**Notice of Decision & SEPA DNS**  
**Woodland Apartments – 1776 N. Goerig Street**  
**Site Plan Review & SEPA DNS**

Land Use Application Nos.:	SPR-23-001 (Site Plan Review Type II) SEP-23-001 (SEPA) VAR-23-001 (Variance)
Applicant & Property Owner:	Goerig St. LLC C/O Aiden Willis 6701 NE 42 <sup>nd</sup> Street Vancouver, WA 98661
Site Location:	1776 N. Goerig Street Woodland, WA 98674
Parcel No. & Size:	50630 (0.9 Acres)
Zoning Designation:	HDR, High-Density Residential
Date Application Received:	January 18 <sup>th</sup> , 2023
Notice of Complete Application Issued:	January 30 <sup>th</sup> , 2023
Notice of Application & Likely DNS issued:	February 1 <sup>st</sup> , 2023
Comment Period & SEPA Appeal Period Ended:	February 22 <sup>nd</sup> , 2023
Notice of Decision Issued:	March 22 <sup>nd</sup> , 2023
DRC Decision	Approve with Conditions

**Attachment A**

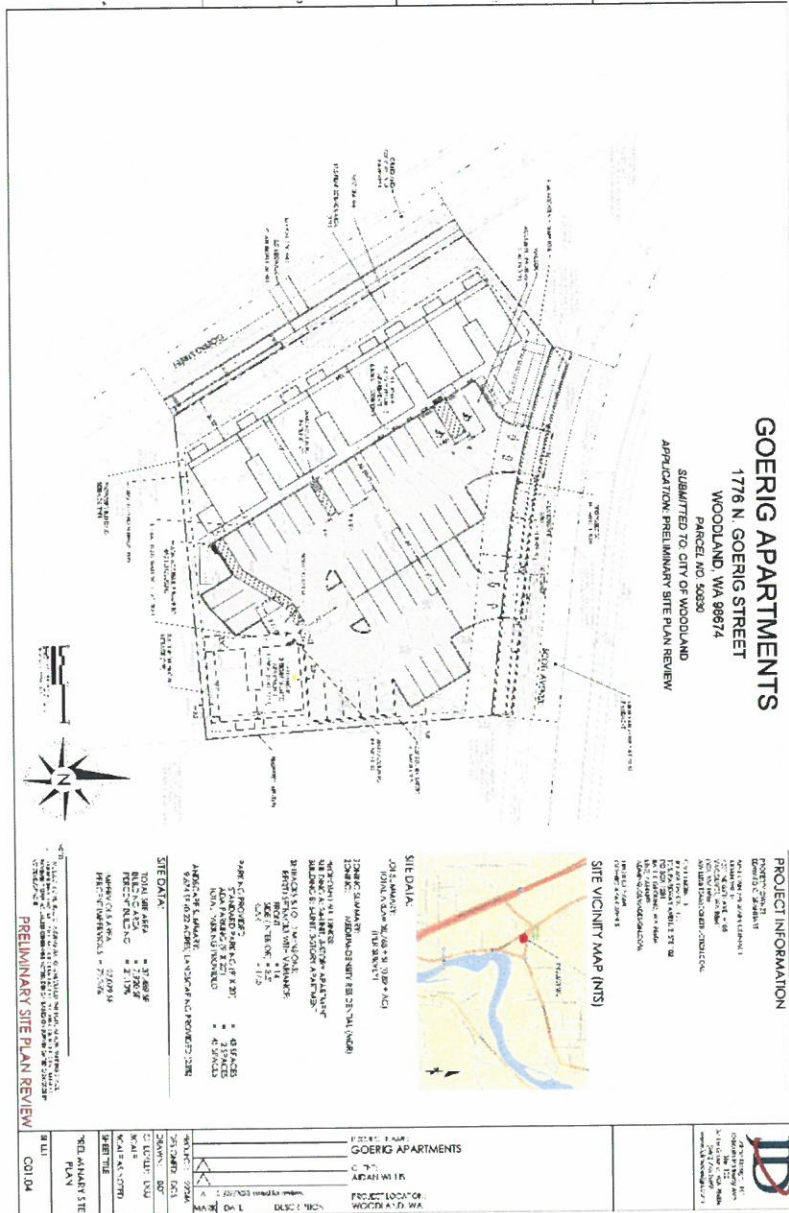
**Finding 20:** The proposed building is set back approximately 14 ft from East Scott Avenue. *See Attachment A – Site Plan.*

**Finding 22:** The proposed building is set back approximately 3.5 ft from all neighboring properties. *See Attachment A – Site Plan.*

**Finding 24:** The proposed building is set back approximately 17.5 ft from the rear property line. *See Attachment A – Site Plan.*

# Attachment B Landscaping Plan

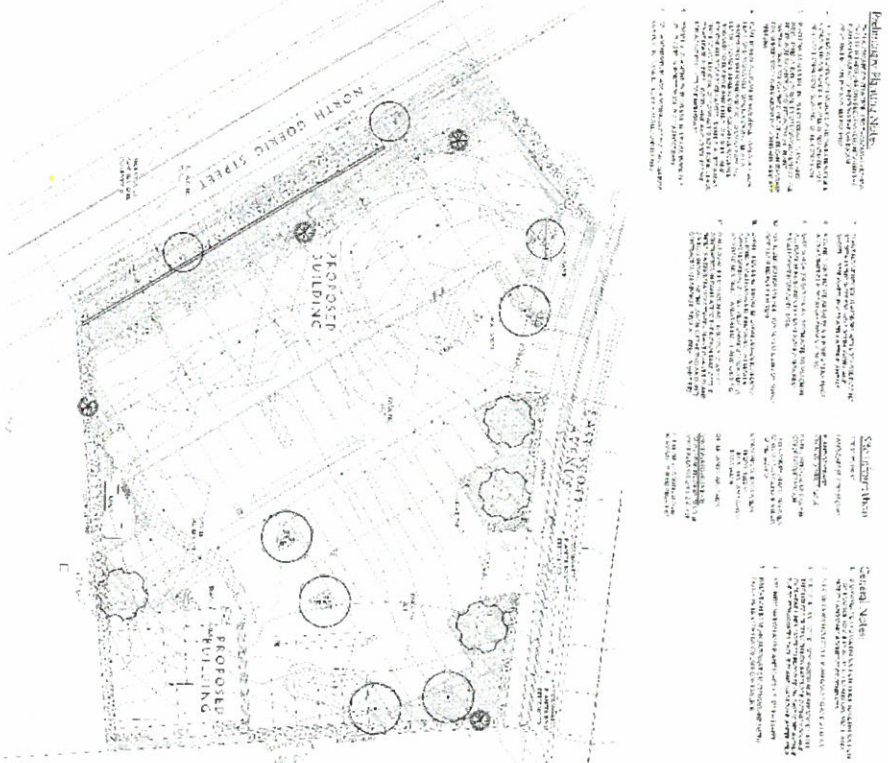
**Finding 37:** A preliminary landscape plan has been provided for new development with the Site Plan Review application. Location of proposed vegetation is provided, as well as the rough size of proposed vegetation, but the final landscape plan will require the identification of all proposed vegetation (using both common and botanical names).

A final landscaping plan is required to be submitted that identifies proposed vegetation (trees and shrubs) and proposed methods of irrigation associated with proposed development. *See conditions #4.*

4. Provide a Final Landscaping plan prepared by a licensed landscape architect alongside civil engineering submittal that meets the following conditions:

- a. Final landscaping plan shall indicate that street trees will be provided along the East Scott Avenue and North Goerig Street frontages by the applicant and/or their designee.

- b. All trees identified in the landscaping plan must identify their caliper size at the time of planting measured at four feet above grade.
  - c. All street trees identified on the final landscaping plan must have a caliper measurement of at least two inches at the time of planting.
